UNITED STATES PATENT AND TRADEMARK OFFICE

10/579,284

Office Action Summary	Application No. 10/579,284	Applicant(s) SCHLEGL ET AL.	
	Examiner MARINA TIETJEN	Art Unit 3753

DETAILED ACTION

Meintschel discloses a lightweight valve (fig. 3) comprising:

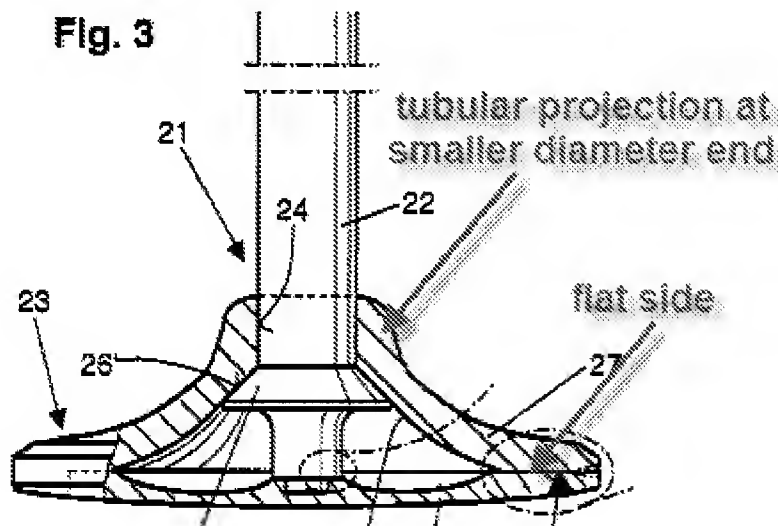
a valve stem (22, fig. 3); a hollow valve cone (27) with a hollow space having an end of greater diameter; and a valve disk (28) closing the hollow space on one side and having a flat side (see labeled fig. 3 below) facing the valve cone (27);

the valve stem (22) being connected to a stem connection element (24) formed on or fastened to the valve disk (28);

a valve cone support (26) located at a distance from the valve disk (28) and provided in the hollow space, the valve cone support (26) being located on the stem connection element (24) and projecting above the flat side (labeled fig. 3 above);

wherein the valve cone support (26) includes at least one supporting surface (26') bearingly contacting an inner wall region of the valve cone (27);

wherein a contour of the supporting surface (26') complements the inner wall region;

wherein the valve cone support (26) is formed by a thickening on the stem connection element (24);

wherein the valve cone (27) is of disk-spring-shaped design (cone has concave shaped surface like a disk-spring);

wherein the valve cone (27) has, at a smaller diameter end, a tubular projection (see labeled fig. 3 above) for guiding through the valve stem (22) or the stem connection element (24);

wherein the valve cone support (26) forms a centering or supporting seat for the valve cone (27); and

However, Meintschel does not disclose the valve disk having a recess serving as a centering or supporting seat for receiving the end of greater diameter of the valve cone, the valve disk including a step extending upward from the flat side of the valve disk so as to define an inner circumference of the recess, the step supporting an inner circumference of the end of greater diameter of the valve cone; wherein the valve disk includes a frusto-conical portion that forms an outer bearing surface of the recess and supports an end face of the end of greater diameter of the valve cone; and wherein a

cone angle of the frusto-conical portion of the valve disk is the same as a cone angle of the valve cone at the end of greater diameter.

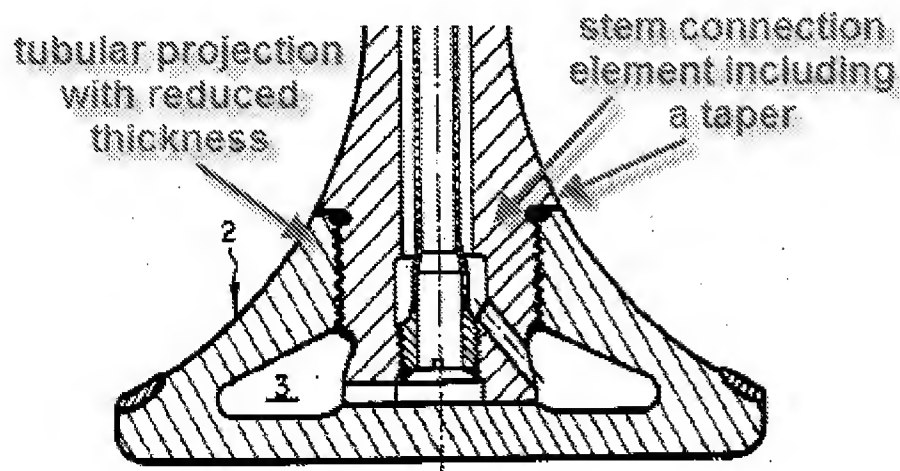
However, Meintschel does not disclose the tubular projection having a reduced thickness in relation to a remainder of the cone so that the tubular projection nestles

against the stem connection element; and wherein the stem connection element includes a taper receiving the tubular projection such that a continuous transition is formed between the tubular projection and the stem connection element.

Ysberg teaches a cone with a tubular projection (see labeled fig. below) having a reduced thickness in relation to a remainder of the cone (2) so that the tubular projection nestles against the stem connection element (see labeled fig. below); and wherein the stem connection element includes a taper (see labeled fig. below) receiving the tubular projection, for the purpose of providing a connection means which provide a smooth transition between the valve stem and the valve cone.

It would have been obvious to one having ordinary skill in the art at the time the invention was made to modify Meintschel's valve, such that the tubular projection is a reduced thickness in relation to a remainder of the cone so that the tubular projection nestles against the stem connection element; and wherein the stem connection element includes a taper receiving the tubular projection, as taught by Ysberg, for the purpose of

providing a connection means which provide a smooth transition between the valve stem and the valve cone.
